ADDENDUM NO.: 01
PROJECT NAME: DUNNE TECHNOLOGY ACADEMY MODERNIZATION
PROJECT NO.: 05440
CONTRACT NO.: C1566
DATE OF ISSUE: February 27, 2015

NOTICE OF CHANGES, MODIFICATIONS, OR CLARIFICATIONS TO CONTRACT DOCUMENTS

PROJECT DUNNE TECHNOLOGY ACADEMY MODERNIZATION		TITLE REVISE NOTE 7, DETAIL #5	
FGM ARCHITECTS <small>CHICAGO OAK BROOK OFALLON ST. LOUIS</small>	DRAWN Author	DATE 02/26/2015	SHEET NO. CSK-001
	APPROVED Approver	JOB NO. 15-1950.01	ISSUED AS ADD #1
PROFESSIONAL DESIGN FIRM - IL # 184-000350

SECTION AT THRESHOLD

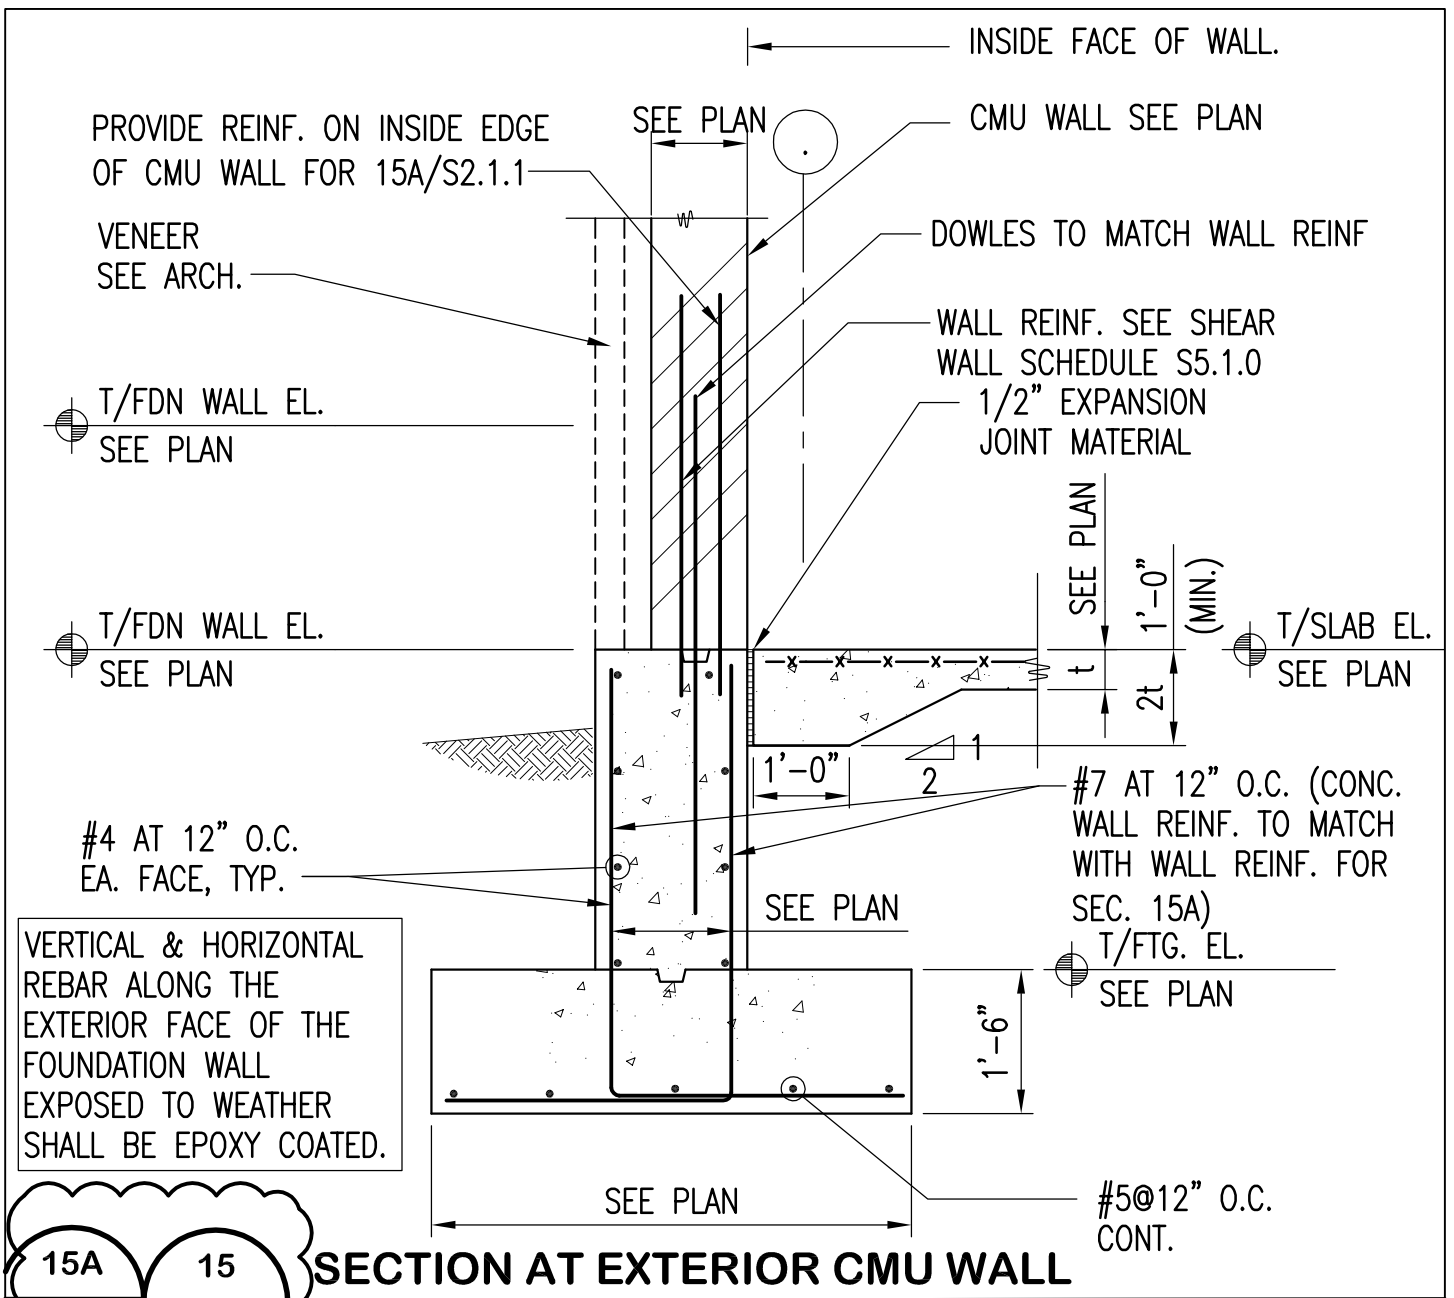
- b. Added corner guards at the locations identified in the revision clouds.
15. SHEET S2.1.1 - FOUNDATION SECTIONS & DETAILS
- a. Detail 5/S2.1.1 is revised (SSK-001)

SECTION AT EXTERIOR CMU WALL

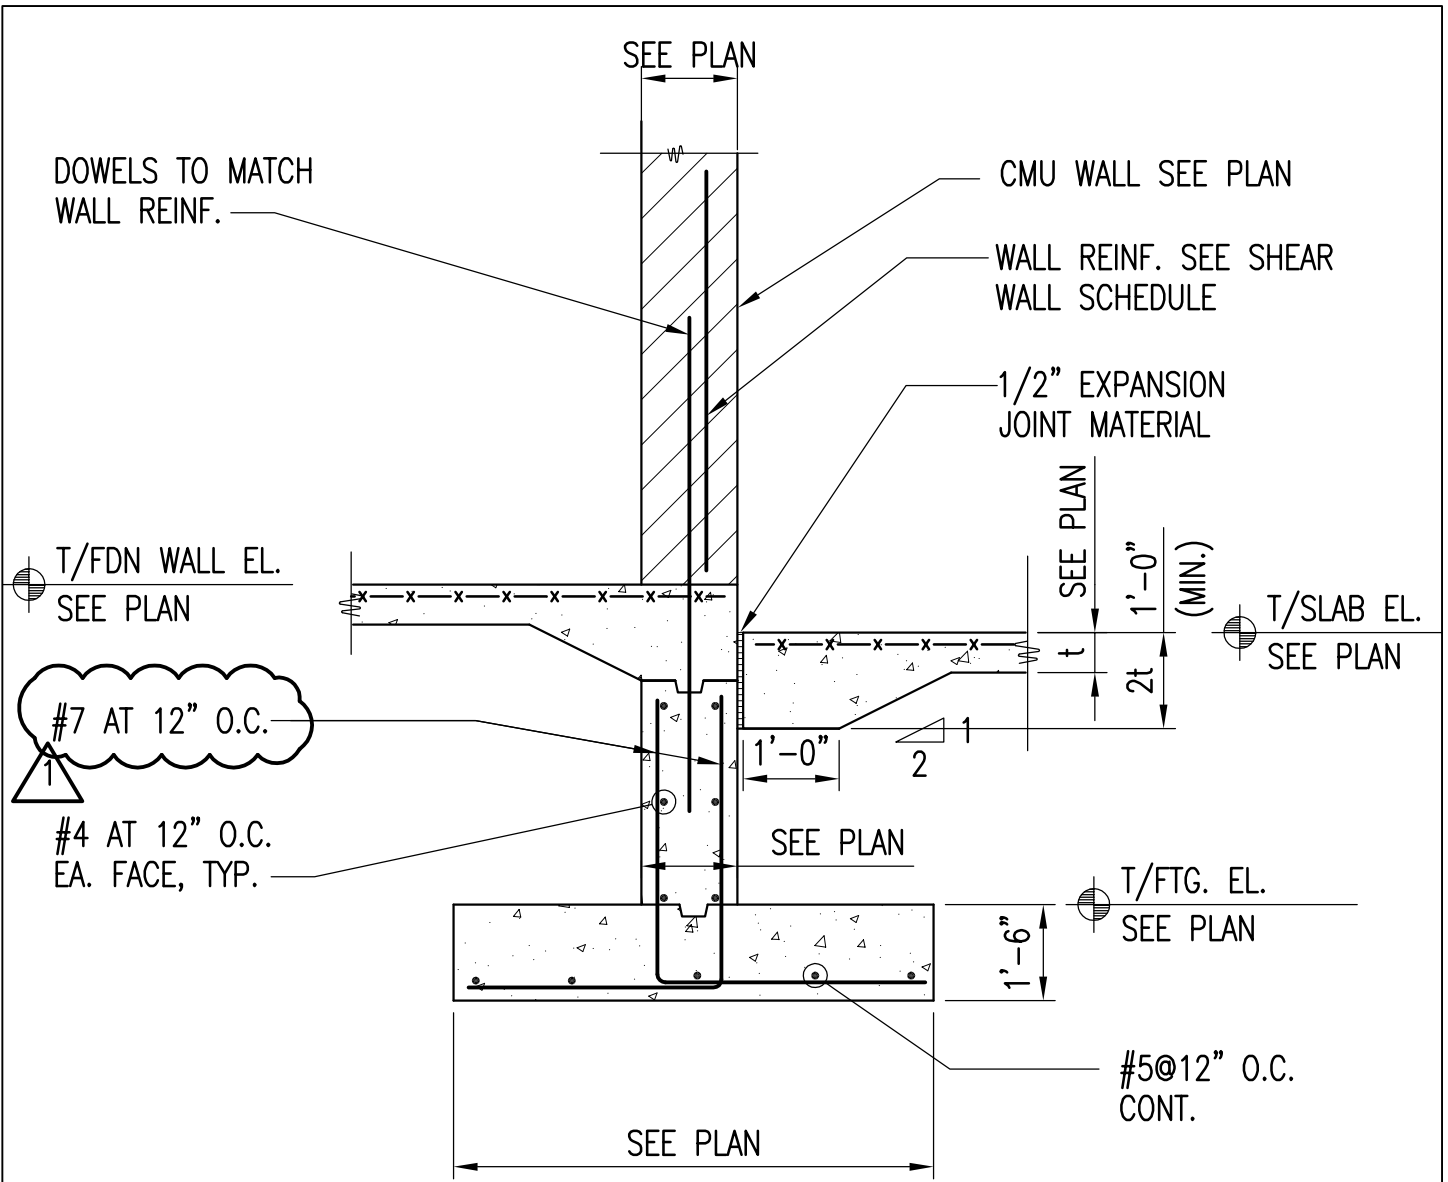
- b. Detail 15/S2.1.1 is revised (SSK-002)
 - c. Detail 17/S2.2.1 is revised (SSK-003)
16. SHEET S6.1.0 - ELEVATIONS
- a. Lintels added (SSK-004, 005, 006)

VERTICAL & HORIZONTAL REBAR ALONG THE EXTERIOR FACE OF THE FOUNDATION WALL EXPOSED TO WEATHER SHALL BE EPOXY COATED.

TITLE **MSK-1-M3-RTU-1&2 SCHEMATICS**

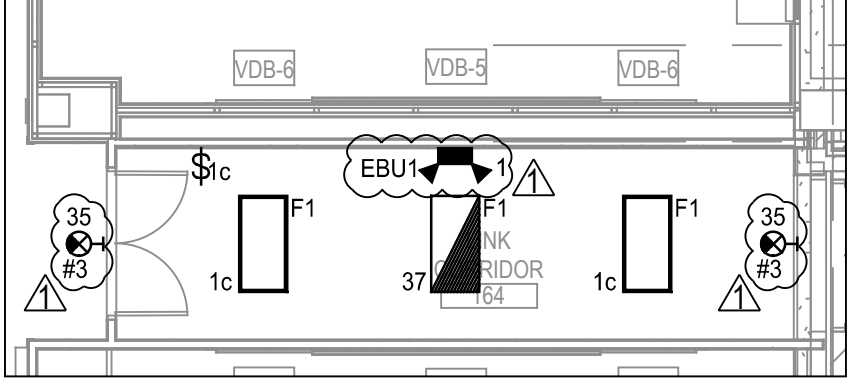
22. SHEET M9.0.1 - MECHANICAL DETAILS
 - a. Insert the attached MSK-1 as M3 showing the schematics for RTU-1 and RTU-2.
23. P1.1.1 FIRST FLOOR PLUMBING PLAN

TITLE **Electrical 1st floor lighting plan,
link corridor revisions**

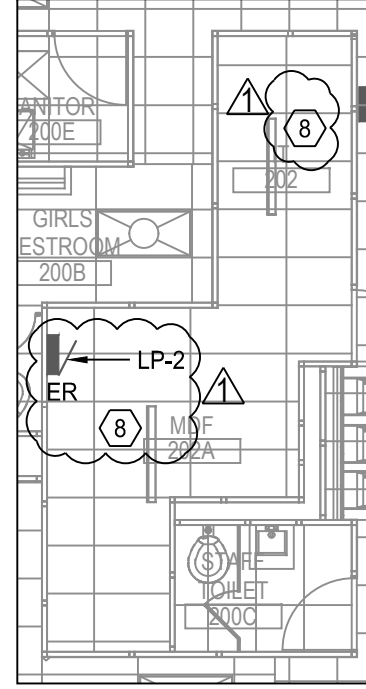
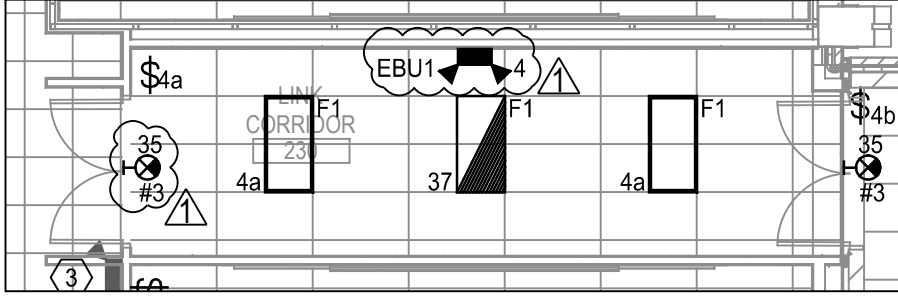
27. SHEET E1.1.1 – ELECTRICAL FIRST FLOOR LIGHTING PLAN (Refer to ESK-001)
 - a. Add emergency battery pack (EBU) and exit signs to link corridor 164.
28. SHEET E1.2.1 – ELECTRICAL SECOND FLOOR LIGHTING PLAN (Refer to ESK-002)

TITLE Electrical 2nd floor lighting plan, link corridor and MDF room revisions

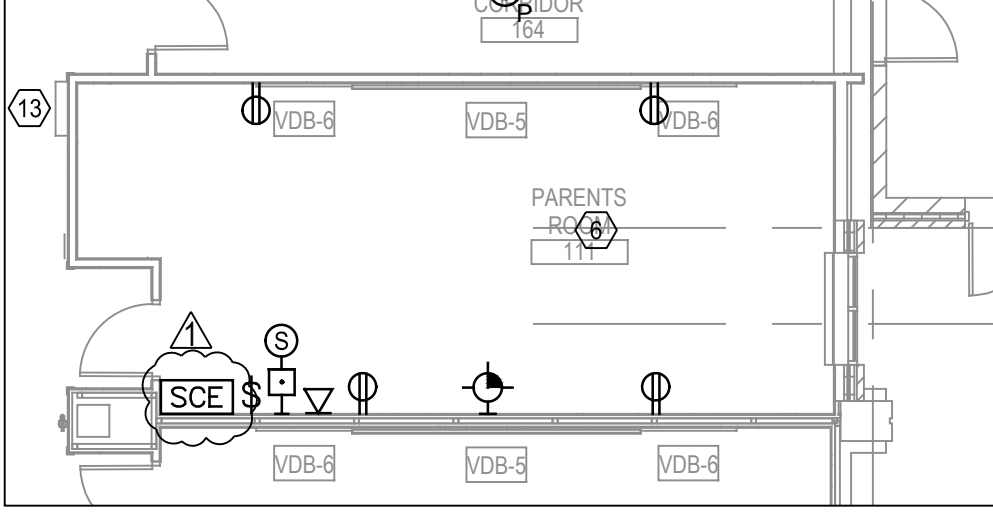
- a. Add emergency battery pack (EBU) and exit signs to link corridor 230.
 - b. Show existing lighting panel LP-2 which feeds existing lighting on the second floor.

- c. Indicate that fixtures in the MDF room need new lenses.
 - d. Add keyed note #4: 'PROVIDE NEW LENSE FOR EXISTING LIGHT FIXTURE.'
 - e. Reword keyed note #1 to indicate 'QUANTITY OF FIXTURE REPLACEMENT ASSUMED TO BE 20%'.

TITLE **Electrical 1st floor power plan,
Parents Room**

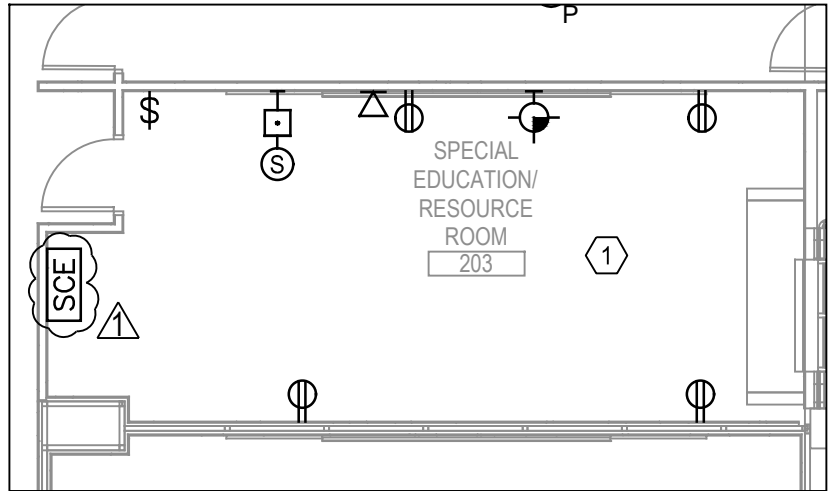
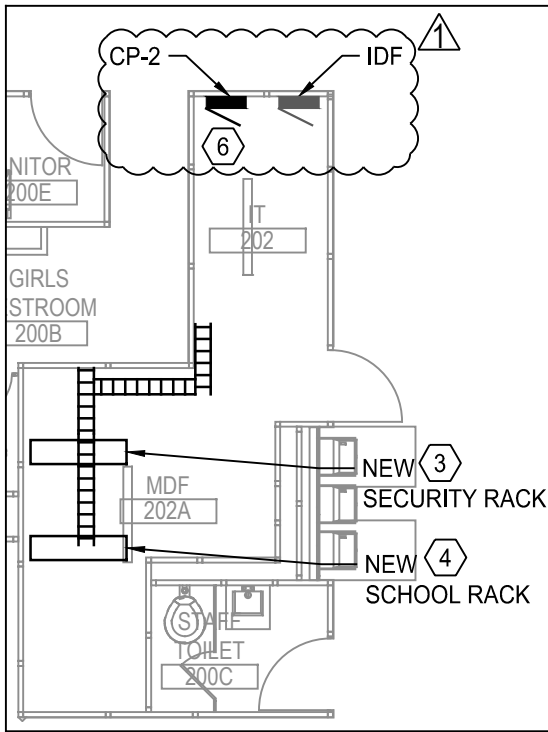
29. SHEET E2.1.1 – ELECTRICAL FIRST FLOOR POWER AND LOW VOLTAGE PLAN (Refer to ESK -003)
 - a. Show existing concentrator box as being reinstalled in Parents Room 111.

PROJECT	DUNNE TECHNOLOGY ACADEMY MODERNIZATION		TITLE	Electrical Details - MDF room	
	FGM ARCHITECTS CHICAGO OAK BROOK ST. LOUIS OF FALLON	DRAWN	AP	DATE	02/26/2015
		APPROVED		PBC JOB NO.	05440
PROFESSIONAL DESIGN FIRM - IL # 184-000350			SHEET NO.	ESK-008	
			ISSUED AS	ADD #1

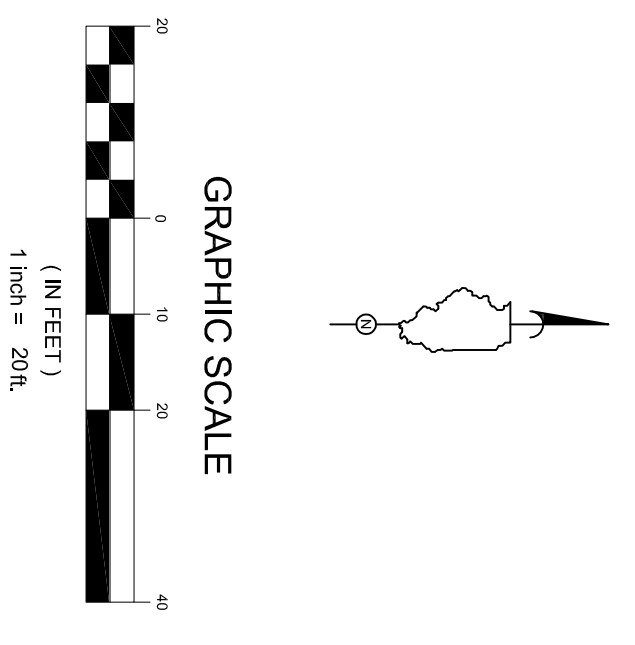
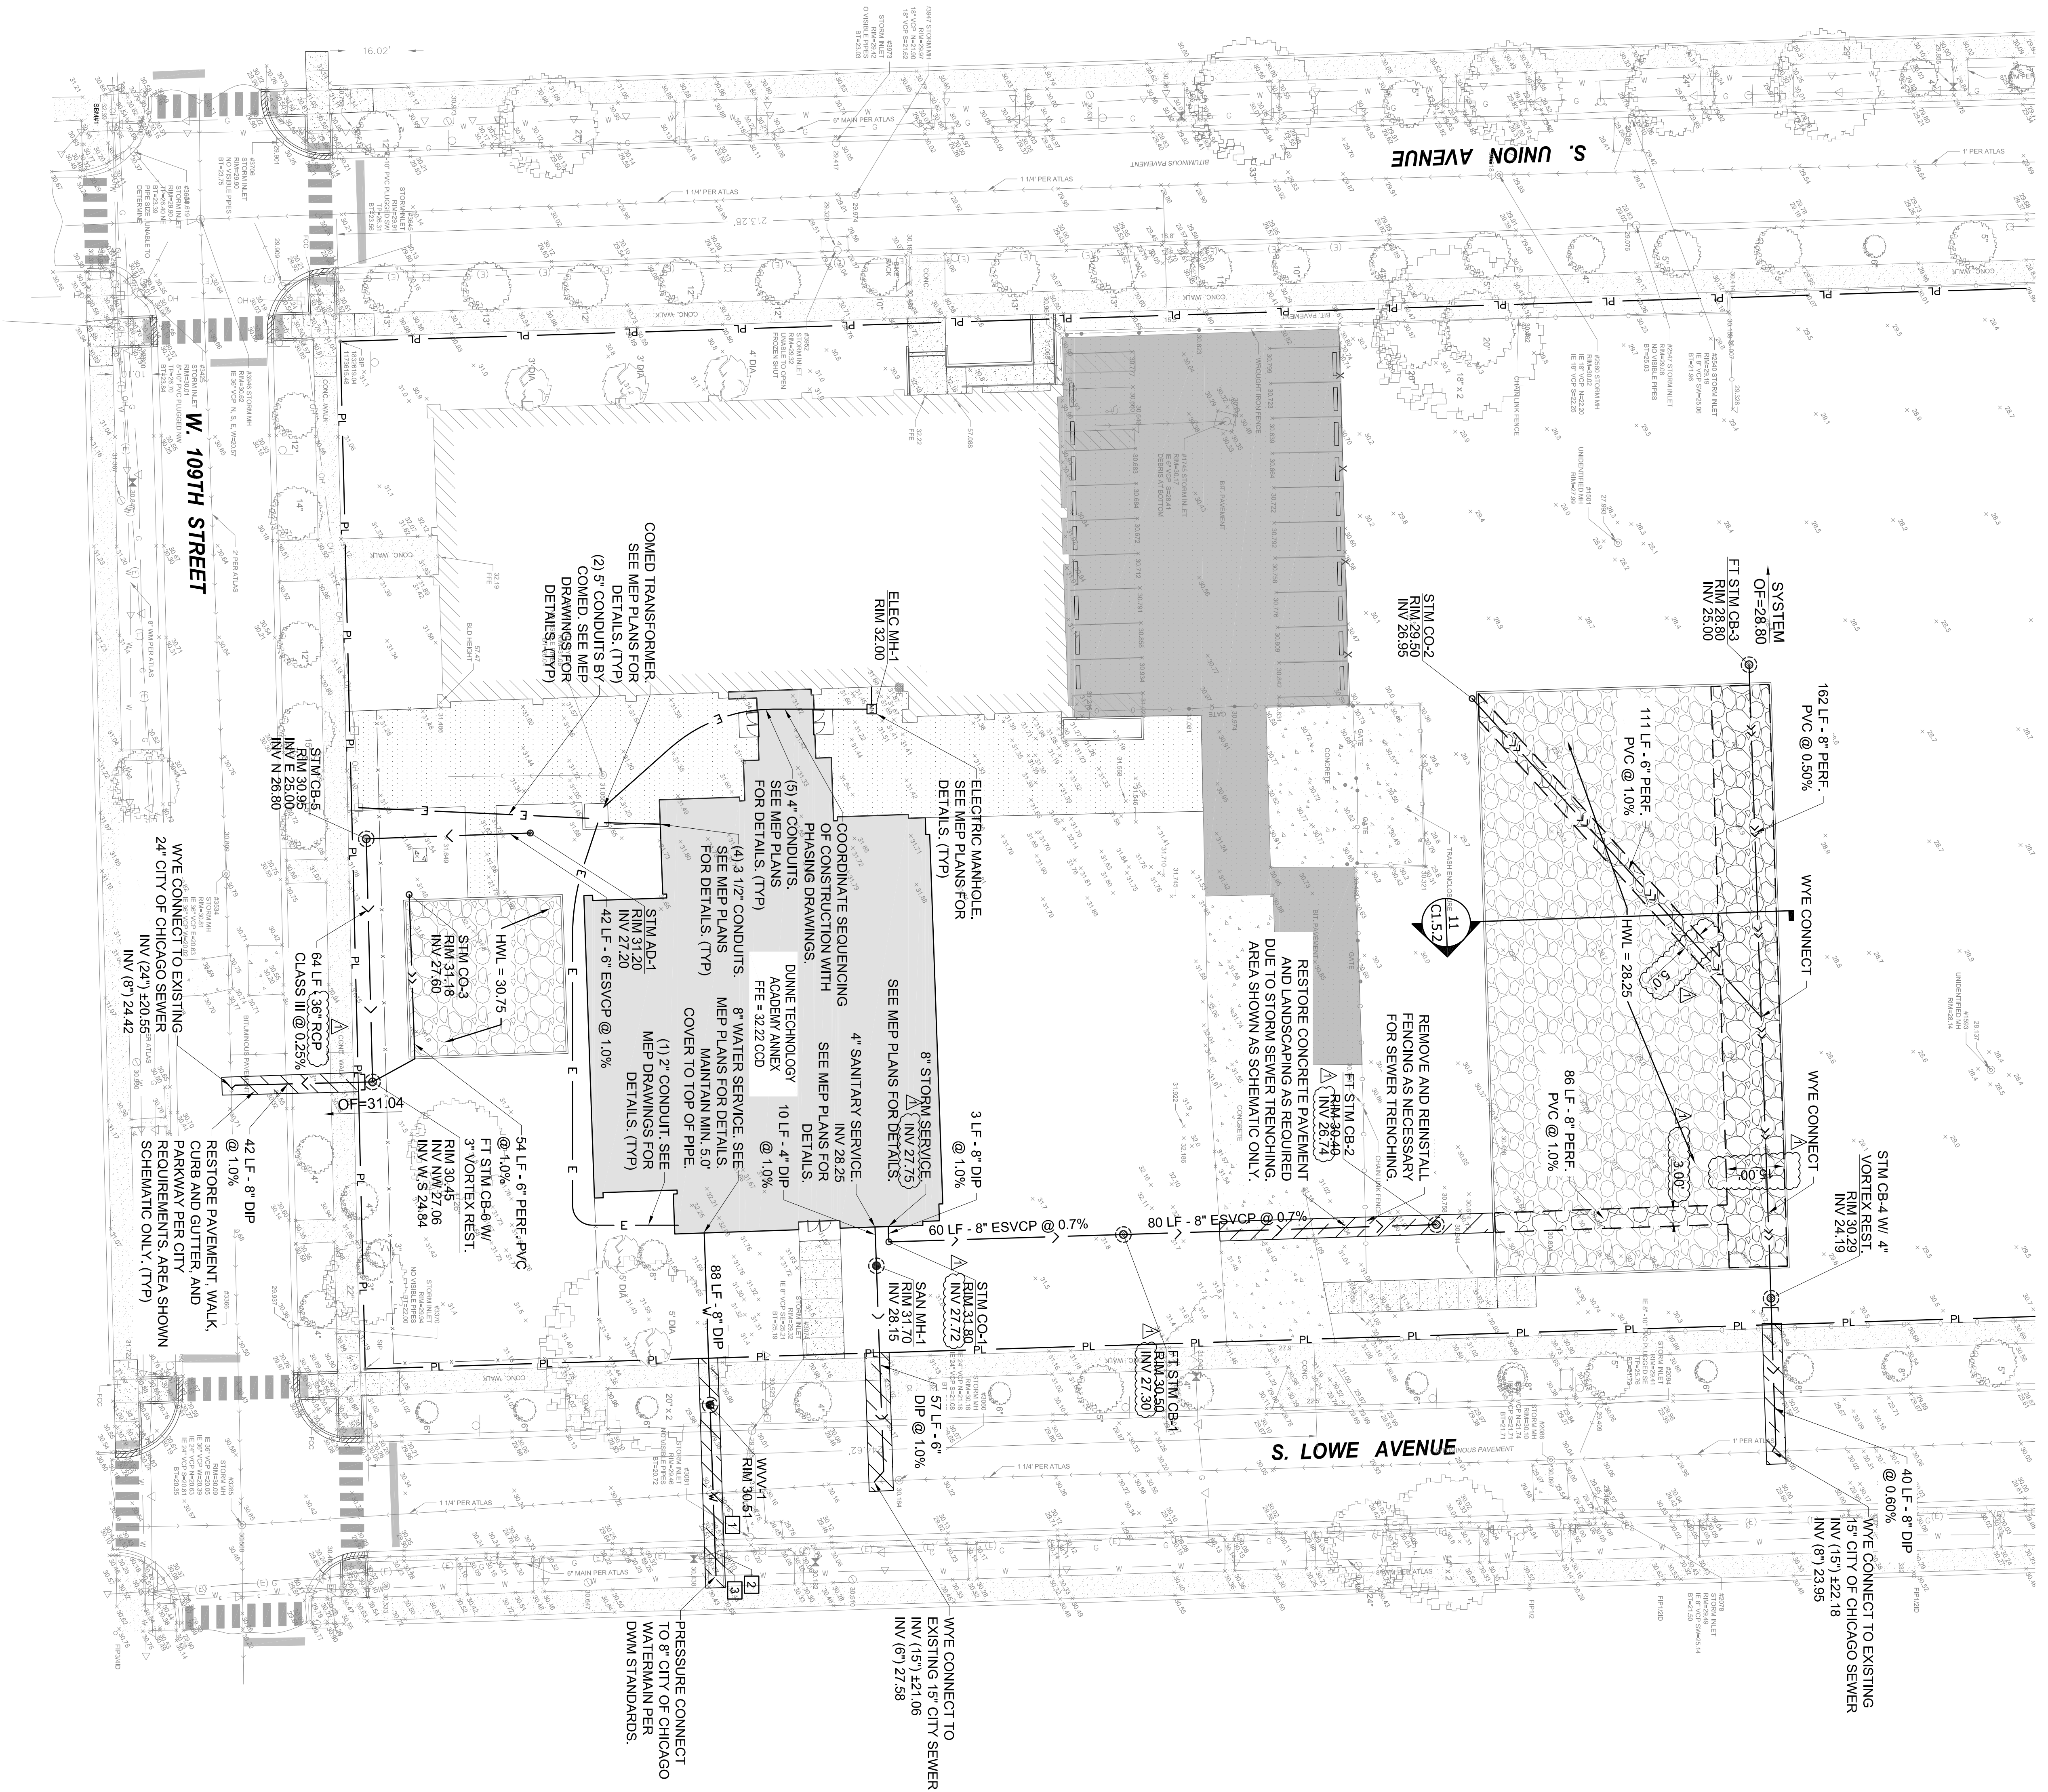
- e. Reword keyed notes #3 and #4 to remove circuit provision information.
31. SHEET E3.1.1 – ELECTRICAL FIRST FLOOR SECURITY PLAN
 - a. Remove glass break device in Gym Office room 158.
 32. SHEET E7.0.1 – ELECTRICAL SCHEDULES (Refer to ESK-005)
 - a. Add F18 feeder for new panel CP-2.
 33. SHEET E7.0.2 – ELECTRICAL PANEL SCHEDULES (Refer to ESK-006)
 - a. Add panel schedule for CP-2.
 - b. Modify load information for LP-3 for addition of new EBUs and exit lights in link corridors.
 34. SHEET E8.0.1 – ELECTRICAL SINGLE LINE DIAGRAM (Refer to ESK-007)
 - a. Add panel CP-2
 35. SHEET E9.0.5 – ELECTRICAL DETAILS
 - a. Modified title of detail E6 to 'TELEVISION MMTV OUTLET DETAIL'.
 36. SHEET E9.0.7 – ELECTRICAL DETAILS (Refer to ESK-008)
 - a. Modified MDF room details to match project requirements.
